North Eastern Regional Power Committee

Sub: 83वीं संरक्षण समन्वय उप-समिति (पीसीसी) बैठक का कार्यवृत्त/ Minutes of 83rd Protection Coordination Sub-Committee (PCC) Meeting

83rd Protection Coordination Sub-Committee Meeting

Date: 18/09/2025 (Thursday)

B.6 Grid Event at Sains 30th Aug'25 and 3rd Sep'25:

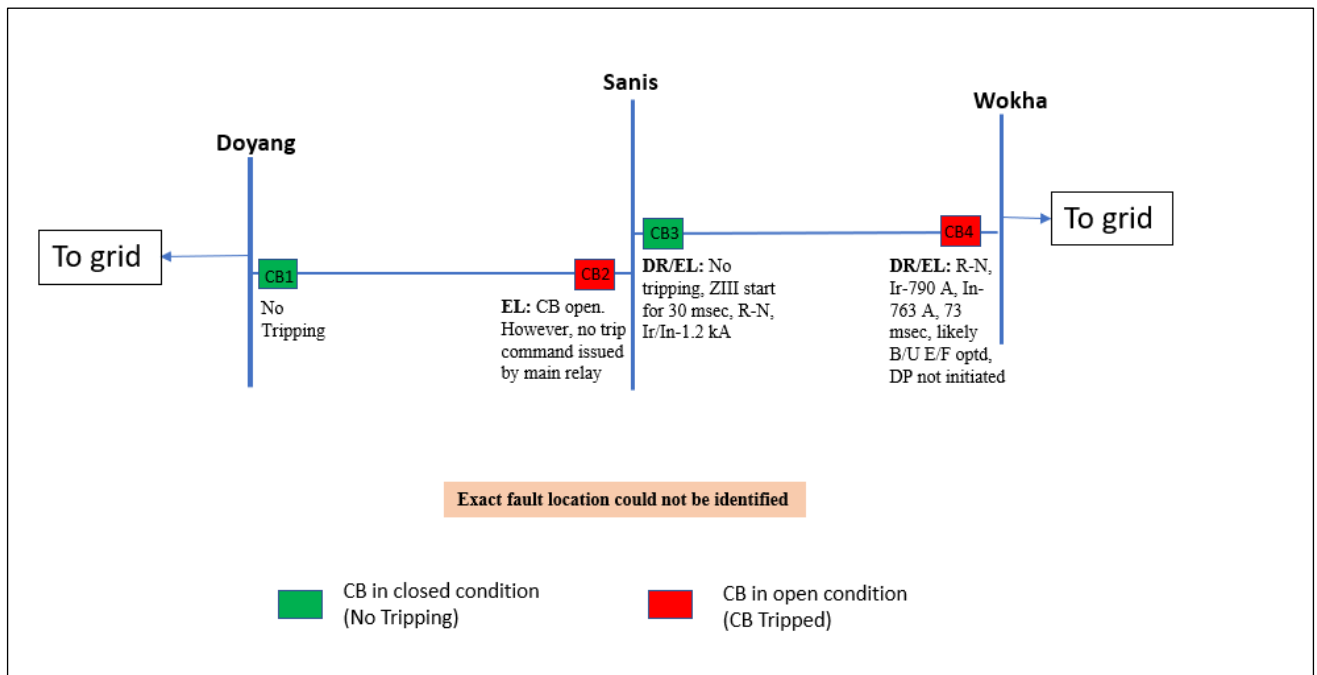
As per DR analysis for Wokha end (Main relay), R-N fault (Ir-790 A, In-763 A) initiated at 12:20:24.888 Hrs which was cleared 73 msec from Wokha end likely on operation of B/U E/F protection ([DR & EL not submitted for backup relay](#)). Also, initiation of backup OC (I_>) & EF (In_{>1}) protection observed in the main relay. Also, main relay not initiated at Wokha end indicates no fault in the 132 kV Wokha – Sanis line.

From Sanis end (main relay), ZIII initiated for R-N fault (Ir-1280 A, In-1250 A) fault current disappeared within 30 msec likely after the CB opening at Sanis end of 132 kV Doyang- Sanis line. However, CB was closed as per submitted DR.

At 12:21:24.143 hrs, 132 kV Doyang-Sanis line tripped from Sanis end. As per the submitted EL (main relay) for Sanis end, no tripping command issued by the main protection. [DR&EL for backup relay not shared by DoP, Nagaland](#).

Exact fault location could not be identified. However, the suspected fault seems beyond the Wokha substation as indicated by the ZIII initiation at Sanis end for 132 kV Sanis – Wokha Line.

DoP, Nagaland to take the following actions:

- I. Share the exact fault location & root cause for the tripping.
- II. Share the reason for tripping of 132 kV Doyang-Sanis line from Sanis end for fault beyond the line (reverse direction) seems unwanted (newly commissioned on 20th Aug 2025).
- III. Share the reason for tripping of 132 kV Wokha-Sanis line from Wokha end for fault beyond the line (reverse direction) in 73 msec seems unwanted.
- IV. Healthiness of the backup relay need to be tested at Sanis & Wokha.
- V. DR downloading facility need to be implemented at Siemens relay at Sanis & Avana make relay at Wokha (otherwise relay replacement to be done).

Root cause: Transient fault due to vegetation occurred on 132kV Wokha-Philimi line (ideally charged line from Wokha).

- The directionality of BU O/C and E/F relay at Wokha S/s for Sanis line (i.e. CB4) was found disabled which has been enabled. Additionally, High Set was also enabled which has been disabled.
- BU O/C and E/F has been enabled in the Main Protection (Distance P442 relay) for Sanis Line at Wokha S/s as the existing BU relay (AVANA NPA-141N) does not have DR recording capability.
- PT neutral point wasn't earthed which has been earthed for 132 kV Bus PT at Sanis.

Forum requested DoP Nagaland to rectify the directionality issue for CB2 by checking the CT polarity.

B.7 Grid Event at Sains, Wokha, Chiephobozou & Zhadima area of Nagaland on 1st Sep'2025:

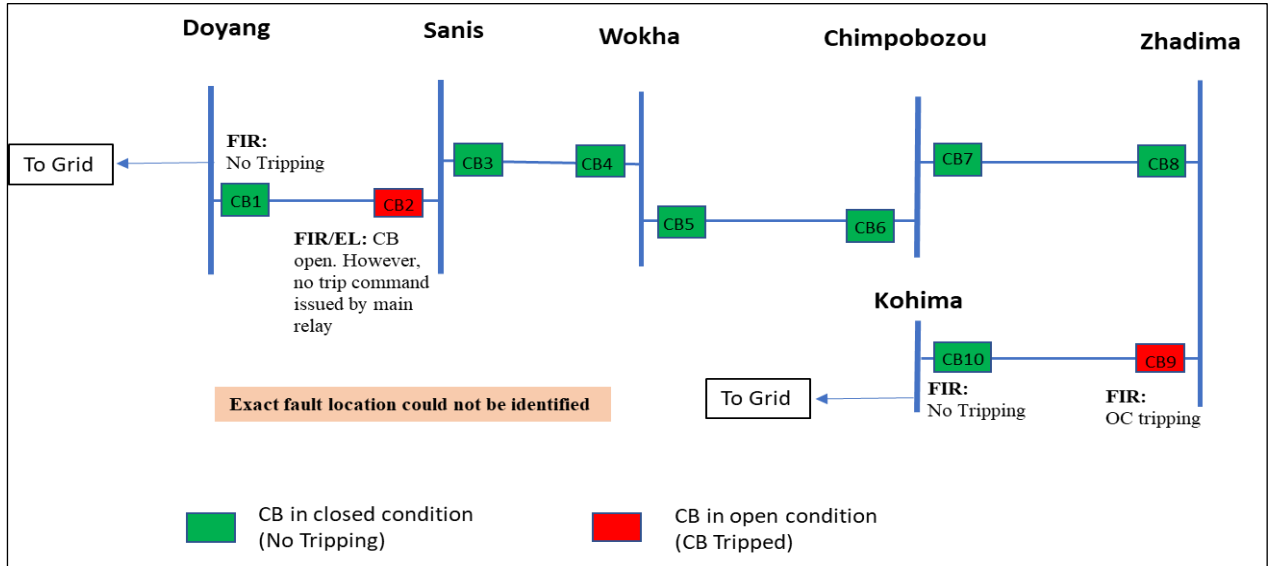
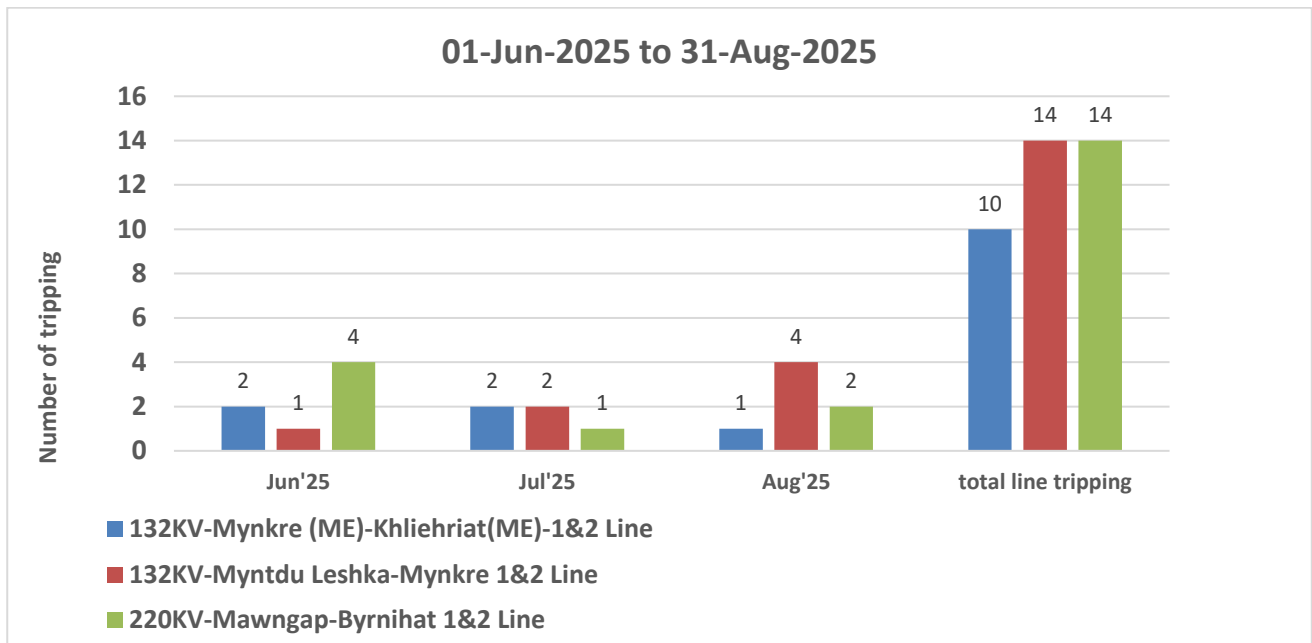
At 09:27 Hrs of 01-09-2025, 132kV Doyang-Sanis and 132kV Kohima - Zhadima line tripped. Due to tripping of these elements, Zhadima, Chiephobozou, Wokha and Sanis areas of Nagaland Power System were isolated from NER Grid.

DoP, Nagaland to take the following actions:

- I. Share the exact fault location & root cause for the tripping.
- II. Share the reason for tripping of 132 kV Doyang-Sanis line from Sanis end for fault beyond the line (reverse direction) seems unwanted (newly commissioned on 20th Aug 2025).
- III. DR downloading facility need to be implemented at Siemens relay at Sanis & Avana make relay at Wokha (otherwise relay replacement to be done).

DoP, Nagaland was absent in the meeting. As per email communication from DoP- Root cause: Transient fault due to vegetation suspected across 132kV Kohima-Zhadima line.

- Vegetation clearance was carried out in suspected fault locations between Kohima and Zhadima.
- BU O/C and E/F has been enabled in the Main Protection (Distance P543 and P442 relays) for Doyang Line at Sanis S/s and Sanis Line at Wokha S/s as the existing BU relay (SIEMENS Reyrolle and AVANA NPA-141N) does not have DR recording capability.

B.10 GD at Rangia and radially fed areas including Bhutan system on 5th Aug'25:

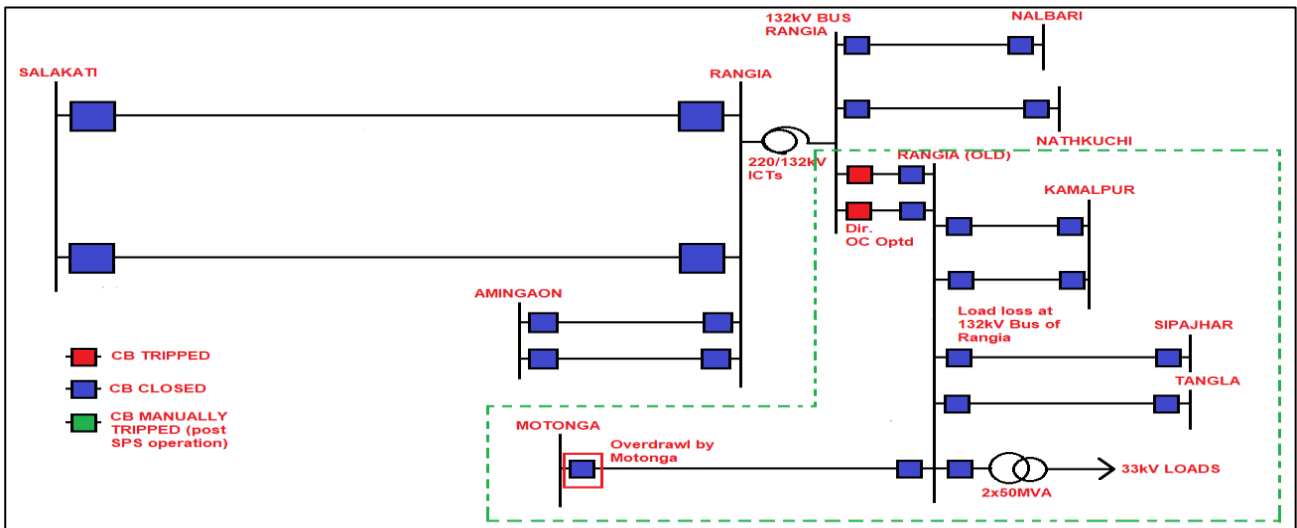
There was no fault observed in the system and the 132 kV Rangia-Rangia(old) DC line tripped on operation of Overcurrent protection due to overloading of the lines. Due to sudden rise in power drawl by 132 kV Motonga feeder due to opening of 132 kV Jigmeling - Tinbiti line in Bhutan, the load in each 132 kV Rangia-Rangia(old) short line increased to 80 MW each. CBs of the short lines at 132 kV Rangia tripped on Directional OC protection.

At Rangia end of **132 kV Rangia-Rangia(old) I-line**, Directional O/C started at **15:39:05.367** Hrs with current of 380-410 A in each phase and tripped at **15:39:45.423 Hrs** (as per AEGCL).

At Rangia end of **132 kV Rangia-Rangia(old) II-line**, Directional O/C operated at **15:39:47.809** Hrs with current of 780-825 A in each phase.

Hence, AEGCL is requested to kindly review the Overcurrent (O/C) relay pickup setting, as the relay operated at a fault current of 380–410 A, whereas the pickup setting was maintained at 440 A.

Also, explore the possibility of increasing the overcurrent settings for the short lines.

AEGCL informed that the OC pick up setting for the Rangia-Rangia line has been kept at around 440 Amps and during the tripping the current had temporarily touched the threshold value.

The forum noted that the GD could have been avoided had there been proper coordination between Bhutan and LDCs (SDLC and NERLDC) before opening of the 132kV Jigmeling-Tinb-Tintibi line by Bhutan. Forum requested SLDC Assam and NERLDC to ensure proper coordination in future.

Forum advised Assam to consider for HTLS upgradation of the Rangia-Rangia line after conducting system studies.

B.11 Tripping of multiple elements at 220 kV Agia substation of Assam on 14-08-2025:

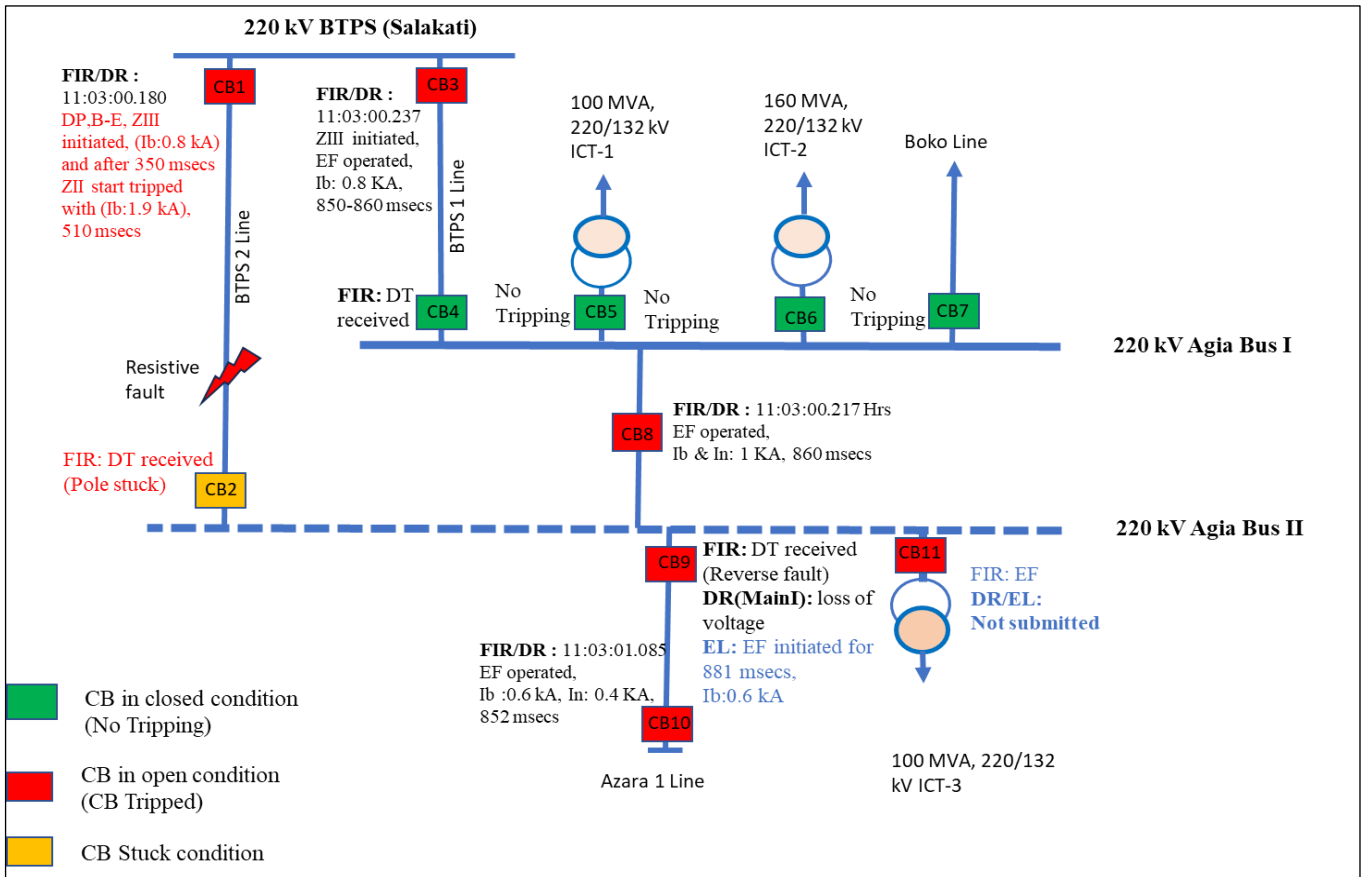
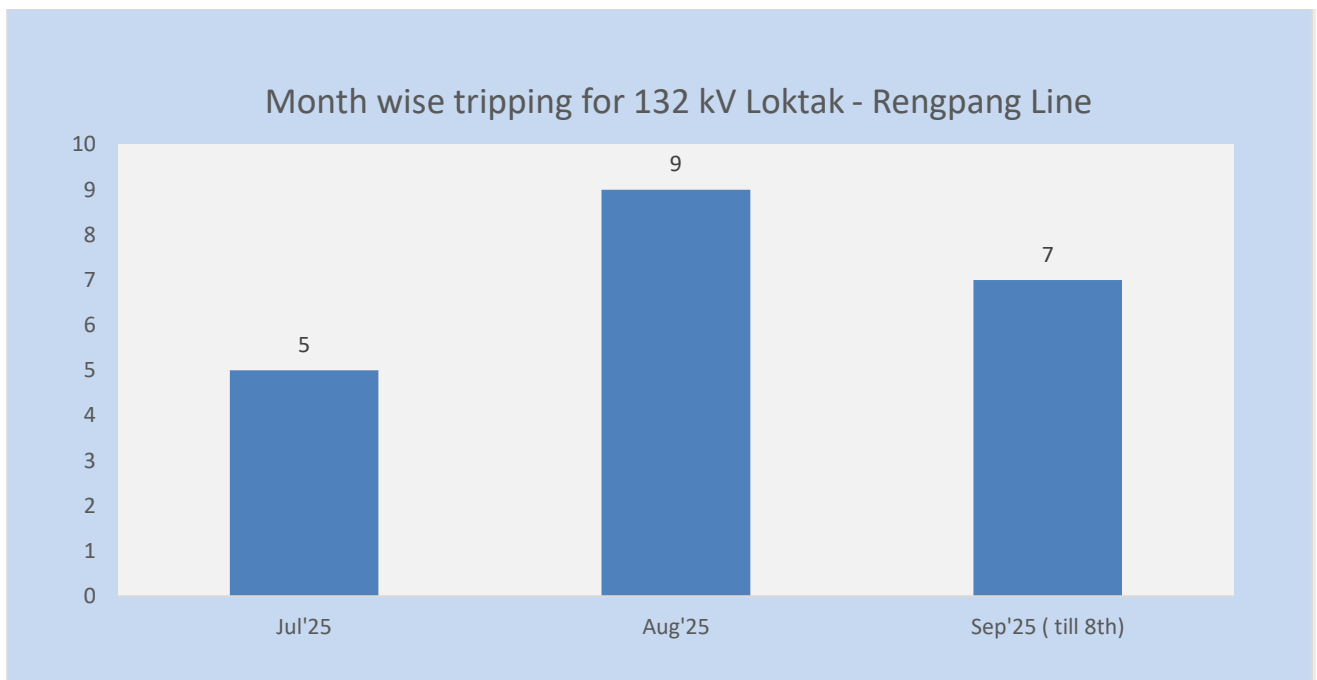
High resistive fault observed in the 220 kV Agia – BTPS II line, cleared from BTPS end by the DP, ZII protection within 510 msecs. Also send DT signal to Agia end. However, the CB got stuck at Agia for the same line.

LBB relay not initiated during the fault at Agia Bus II.

The fault was cleared from the system by tripping of 220 kV Agia – BTPS I line, Bus Coupler & 220 kV Agia–Azara Line in 850-860 msecs.

Also, the fault persisted in the system for 1670 msecs and finally cleared by tripping of ICT-3 which causes the blackout of Bus II at Agia SS.

1. Share the reason for non-operation of LBB relay for Agia Bus II.
2. Share the reason for EF pickup at Agia end for 220 kV Agia - Azara Line & ICT-3.
3. Share the reason for DT sent (as informed verbally) from BTPS end for ZII tripping.
4. DT received & DT sent need to be incorporated in the DR for each element.

AEGCL informed that DT was sent from the BTPC end as per the philosophy set by the OEM. Further he informed that the pole issue has been resolved.

1. Rectify the directionality issues of CB11 and CB9
2. Rectify the LBB issues for Agia Bus II
3. set the DT sending philosophy only as per the NERPC protection protocol

4. Coordinate the timing of the EF protection of the Bus coupler at Agia with the ZII of the CB3.
5. DT received & DT sent need to be incorporated in the DR for each element.

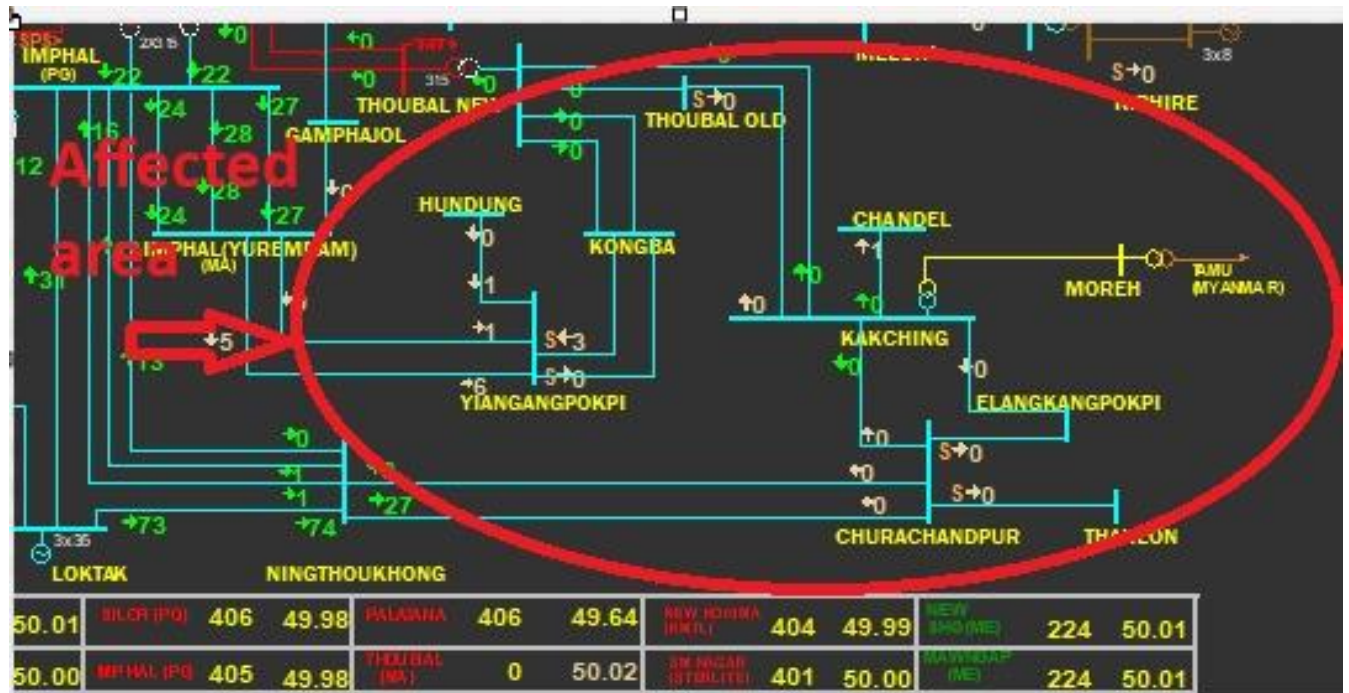
Multiple areas of Manipur were feeding through Imphal & Ningthoukhong substation with 132 kV Ningthoukhong-Churachandpur 2 line and 132 kV Imphal-Yiangangpokpi I line only.

- I. Requirement of the testing of the static relay at Ningthoukhong to check the healthiness (as per setting relay should not have operated due such loading). Also, static relays to be replaced with numerical type as early as possible.
- II. Backup setting need to be incorporated in the main to cross verify the performance of the backup OC, EF relay (static relay) at Ningthoukhong.
- III. Overloading setting need to be revised for 132 kV Imphal – Yiangangpokpi 1 line (currently pickup current: 300 A only).
- IV. Time drift of 1 hr observed in the DR of Yurembam (Imphal). The same need to be matched.
- V. Time synchronizer need to installed at Imphal & Ningthoukhong as early as possible.

1. MSPCL Revised the O/C pickup current setting at Yurembam for the Yiangangpokpi line to 450 Amps.

2. Replace all the static and electromagnetic relays with the numeric relay in their system
3. Put the B/U protection settings in the Main relay at Ningthoukong for the Churachandpur line.
4. Perform testing of the static relay at Ningthoukong to check the healthiness (as per setting relay should not have operated due such loading).
5. Time synchronizer need to installed at Imphal & Ningthoukong as early as possible.

C.1 Grid Disturbance in Mynkre area and Leshka HEP of Meghalaya Power System on 1st June'25:

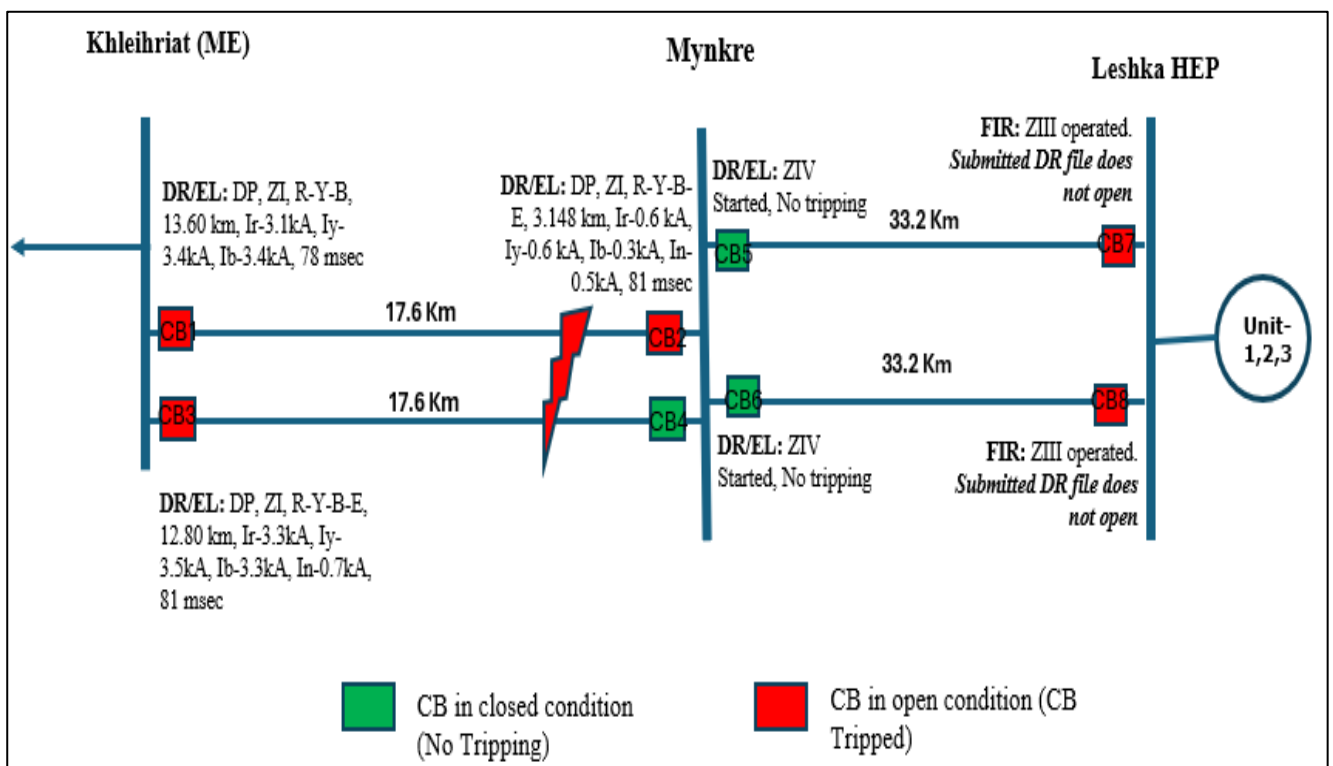
At 05:37 Hrs of 01-06-2025, 132kV Mynkre (ME)- Khliehriat(ME) D/C lines and 132kV Mynkre-Leshka D/C lines tripped resulting in grid disturbance in Mynkre area and Leshka HEP of Meghalaya Power System. Generation loss of 84 MW occurred.

As per DR analysis of 132 kV Mynkre (ME)-Khliehriat(ME) 1 line, solid R-Y-B fault (Ir-3.1 kA, Iy-3.4 kA, Ib-3.4 kA) initiated at 05:37:08.630 Hrs which was cleared within 81 msec on operation of DP, ZI.

C.4 (Agenda B10, 82nd PCC) Grid disturbance in Umiam Stg III and New Umtru areas of Meghalaya power system on 21st July'25:

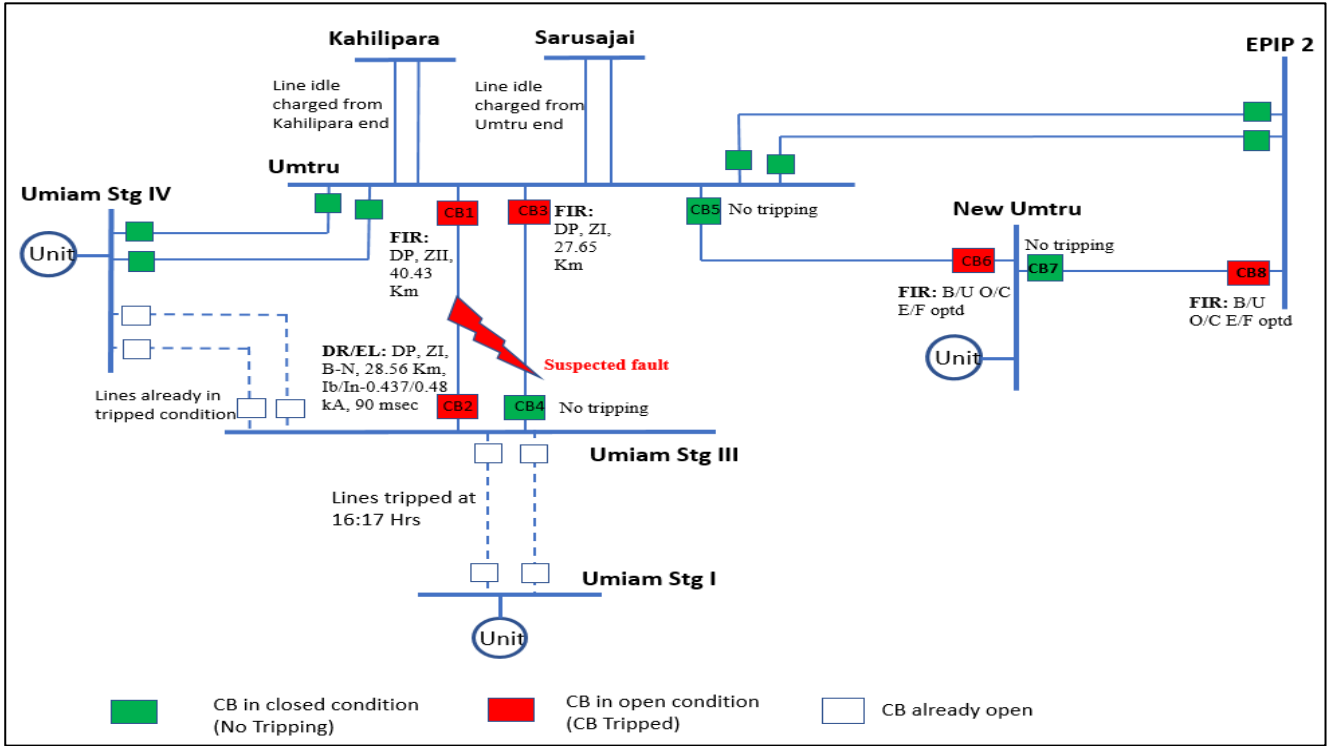
At 16:44 Hrs of 21-07-2025, 132 kV Umtru – Umiam Stg III D/C lines, 132 kV New Umtru – Umtru, and 132 kV EPIP 2 – Umtru II and New Umtru HEP Unit-1 tripped resulting in blackout of Umiam Stg III & New Umtru S/S of Meghalaya power system. Generation loss of 20 MW.

As per DR analysis of 132 kV Umtru-Umiam Stg III Line-1, B-N fault (Ib-437 A, In-480 A) initiated at 16:44:00.235 Hrs which was cleared within 90 msec from Umiam Stg III end on operation of DP, ZI. ZII operated from Umtru end (as per FIR, DR/EL file not opening)
